8.2 Development Control Plan (DCP) Amendment No. 6 - Post Exhibition Report

REPORT BY THE MANAGER PLANNING AND MANAGER, INFRASTRUCTURE PLANNING

TO 19 JULY 2023 ORDINARY MEETING GOV400103, LAN900166

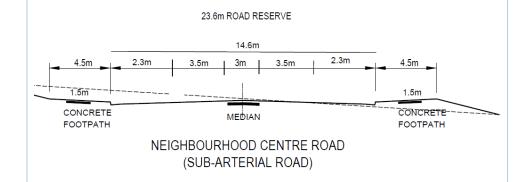
Submission Issue The Neighbourhood Centre Road as it has evolved through the Estate, at the location of the Neighbour Centre passes to the west of the Centre. and does not actually traverse it. Accordingly, the 60 degree angle parking poses a safety issue as the turning/reversing manoeuvres will conflict with the higher order function of a major collector road. The parking is best placed as offstreet parking within the proposed neighbourhood Centre.

The received submission proposes a cross section which would provide for the following:

The implications of this proposal are as follows:

- Parking will be removed from both the east (neighbourhood centre) and west (residential) sides of the road leaving only a 1.5m shoulder which may encourage parking on the nature strip of visitors and resident cars;
- Painted median would not provide a good visual buffer between residential (west side) and commercial development (east side) and may be considered a degradation to urban design quality expected in a residential estate
- Any development application for the neighbourhood centre would be assessed on the basis that all car parking requirements for the neighbourhood centre development (as per the Mid-Western Regional Council DCP) is internal of the site. This may lead to refusal of development applications or degradation from highest and best use of the site

In consideration of the received submission the following alternative would be an acceptable arrangement to be included on both the east and west side of the road:

- 3m median to remain a landscaped median with pedestrian refuge(s) in key location(s);
- minimum 2.3m parallel parking (AS2890.1:1993); and
- minimum 3.5m travel lanes (to accommodate bus route in accordance with Austroads Guide to Road Design Part 3; Geometric Design section 4.9.2)

This would provide a minimum cross section road reserve width of 23.6m.

2013 Caerleon DCP

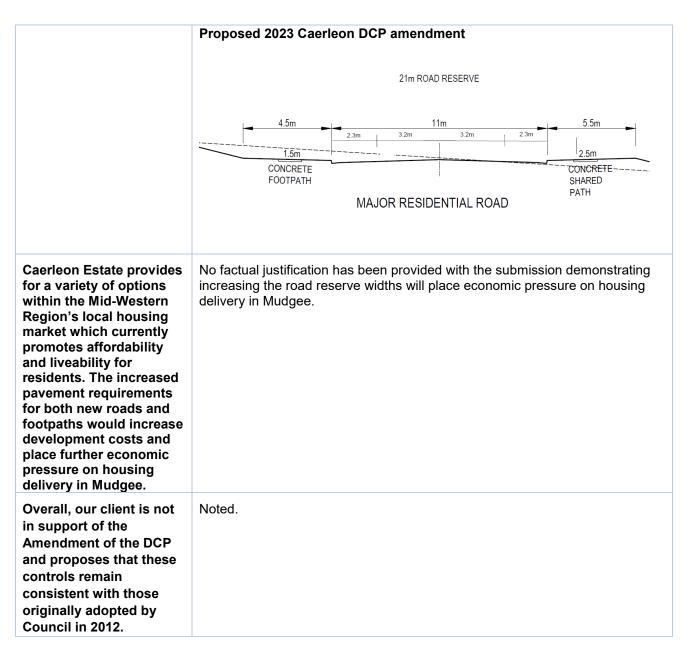
Similar concerns are raised for the increase in widths of major residential roads from 18m to 21m reserves.

Currently the 2013 Caerleon DCP provides for a 18m road reserve width which includes $2 \times 1.2 \text{m}$ footpath or $1 \times 2.0 \text{m}$ shared path, nature strip widths of 3.5 m and 11 m carriageway.

As mentioned above the 1.2m footpath width or 2.0m wide shared path is no longer industry standard. 2.0m wide footpaths and shared paths of 2.5m-3.0m are now becoming the standard (refer TfNSW July 2020 Walking Space Guide). The 3.5m wide nature strip with 2.0m shared paths constructed to date bring difficulty in achieving special separation of Public Utility services and, in some locations constructed to date, does not meet Councils standard for services not to be located below a pathway.

In the proposed 2023 Caerleon DCP amendment Council is willing at this stage to compromise with the provision of a 1.5m footpath and 2.5m shared path. This requires nature strips to be widened to 4.5m in the location of footpaths and 5.5m in the location of shared path. Road carriageway width of 11m is maintained in accordance with the 2013 Caerleon DCP and overall cross section and is generally in accordance with the Mid-Western regional Council DCP.
